## King County

### Wastewater Treatment Division

## Errata to the Final Environmental Impact Statement for the Brightwater Regional Wastewater Treatment System, November 2003

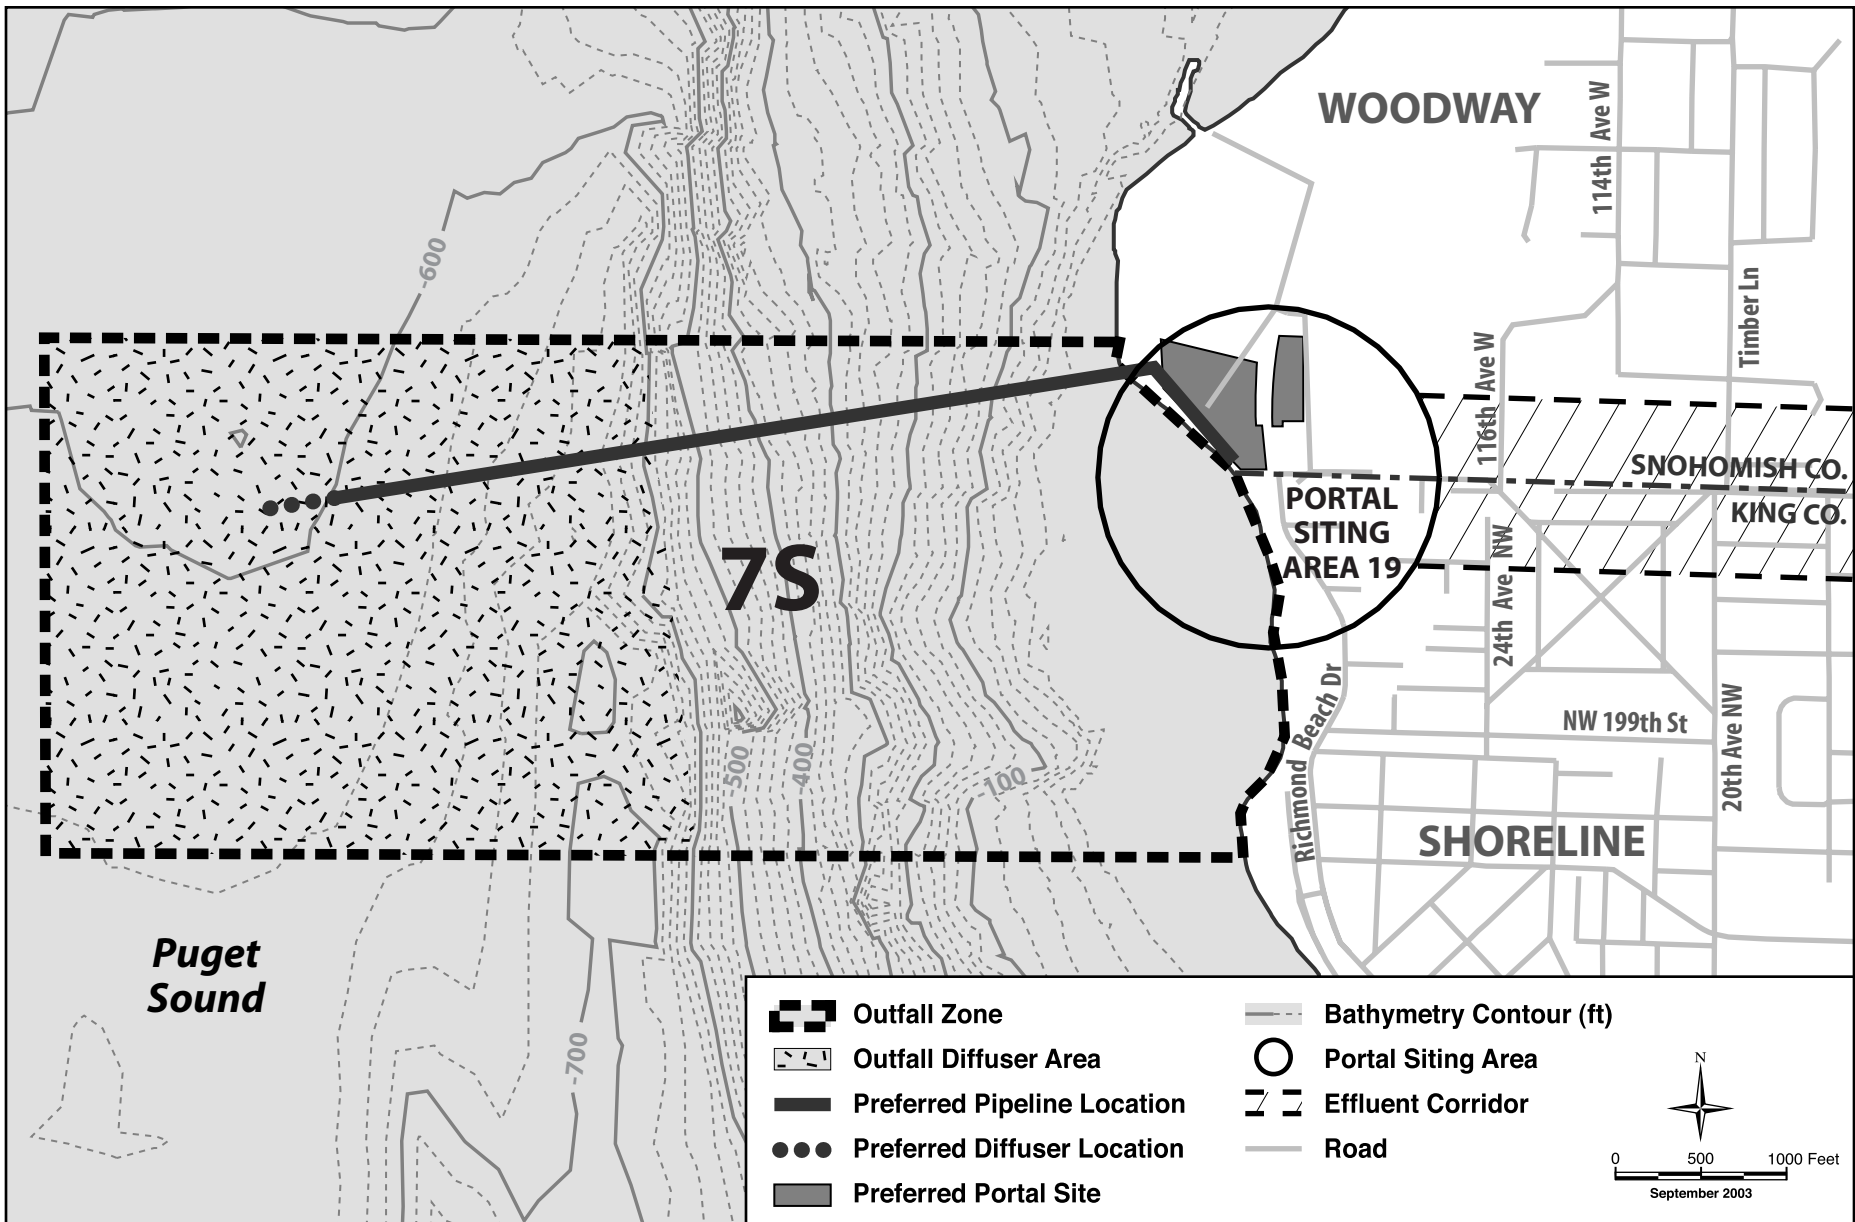
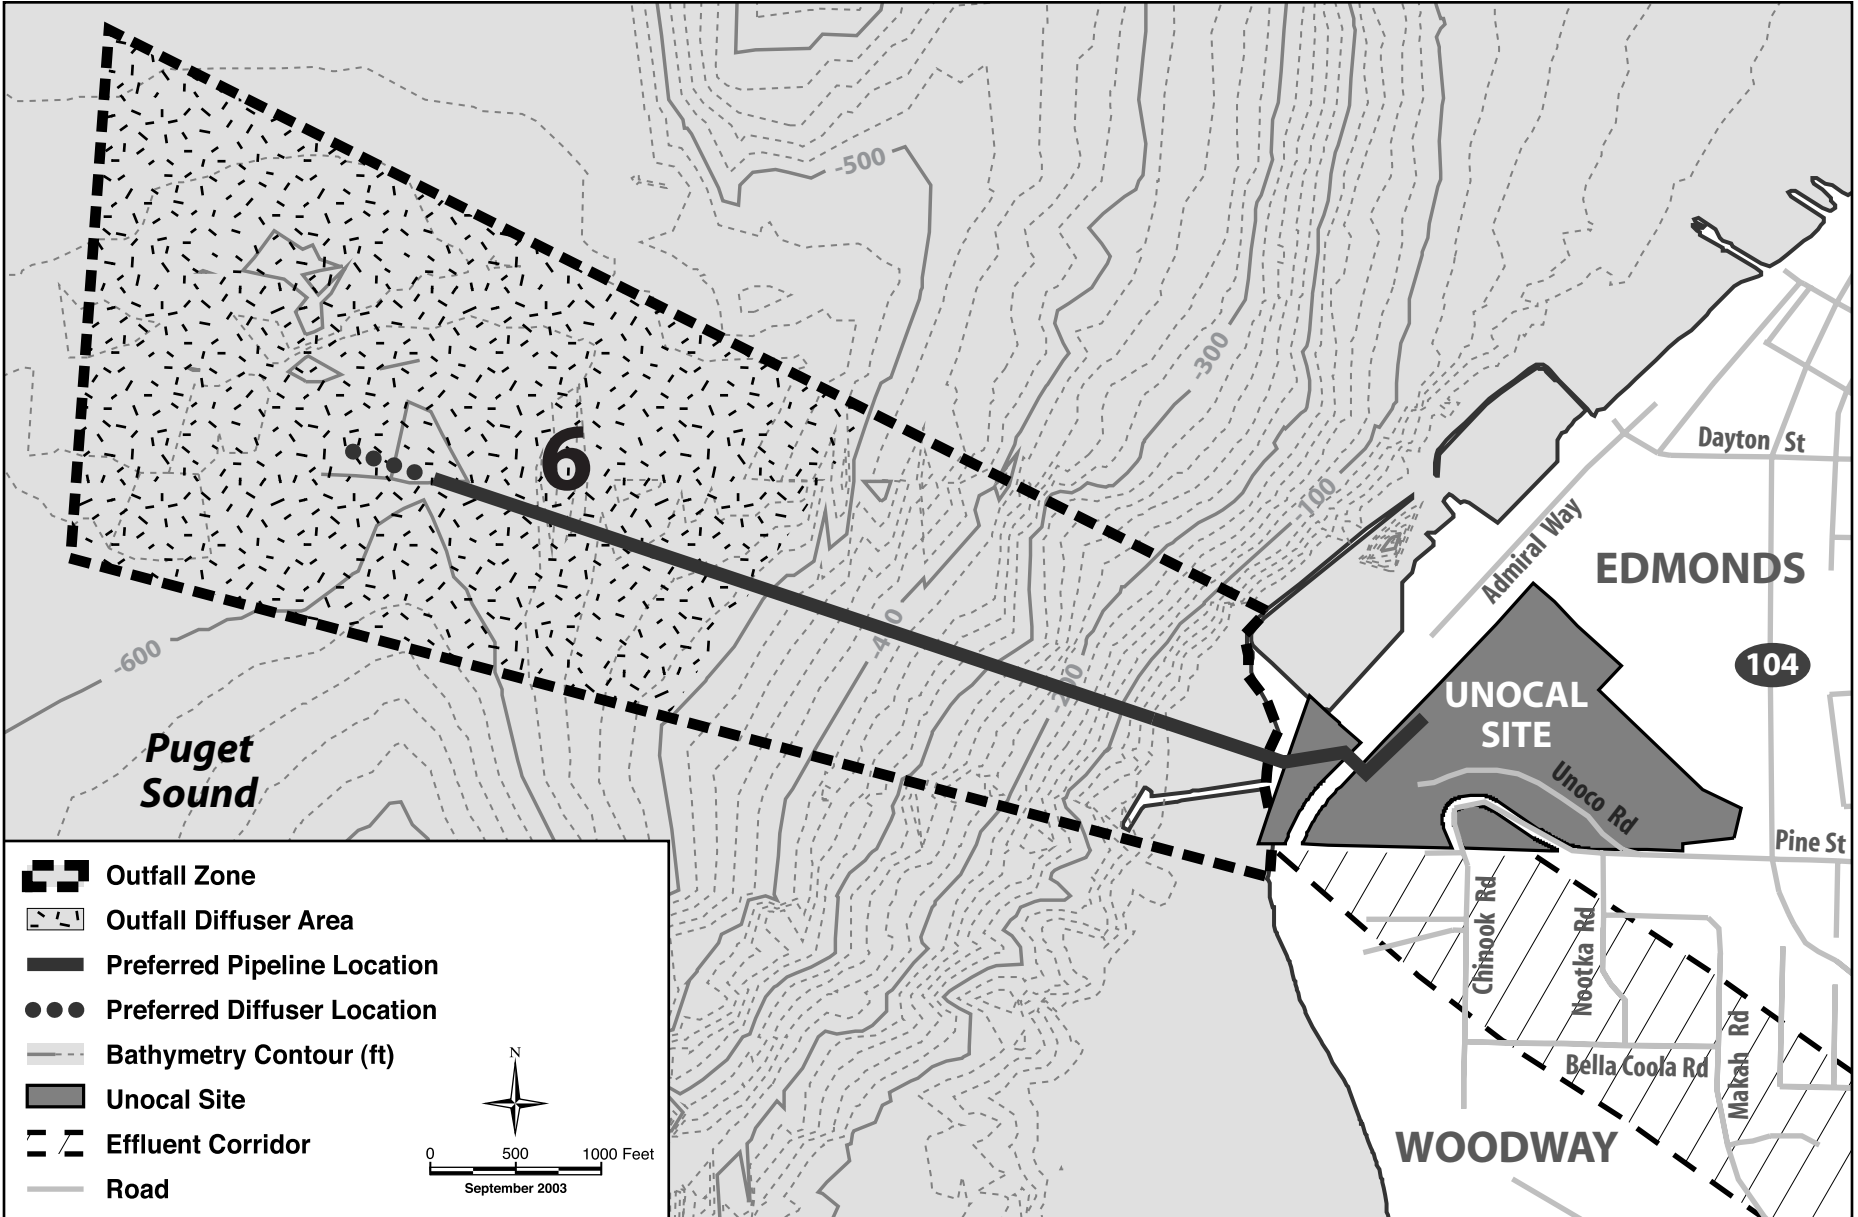
Because of a printer's error, Figure 3-9, "Outfall Zone 7S and Preferred Outfall Alignment for Route 9 Systems," and Figure 3-21, "Outfall Zone 6 and Preferred Outfall Alignment for Unocal System," included in the Final EIS were from a previous draft of the document and are incorrect. The figures intended to be used and depicted are attached to this errata as Figures 3-9 and 3-21. The correct figures each depict only one outfall alignment for each alternative.
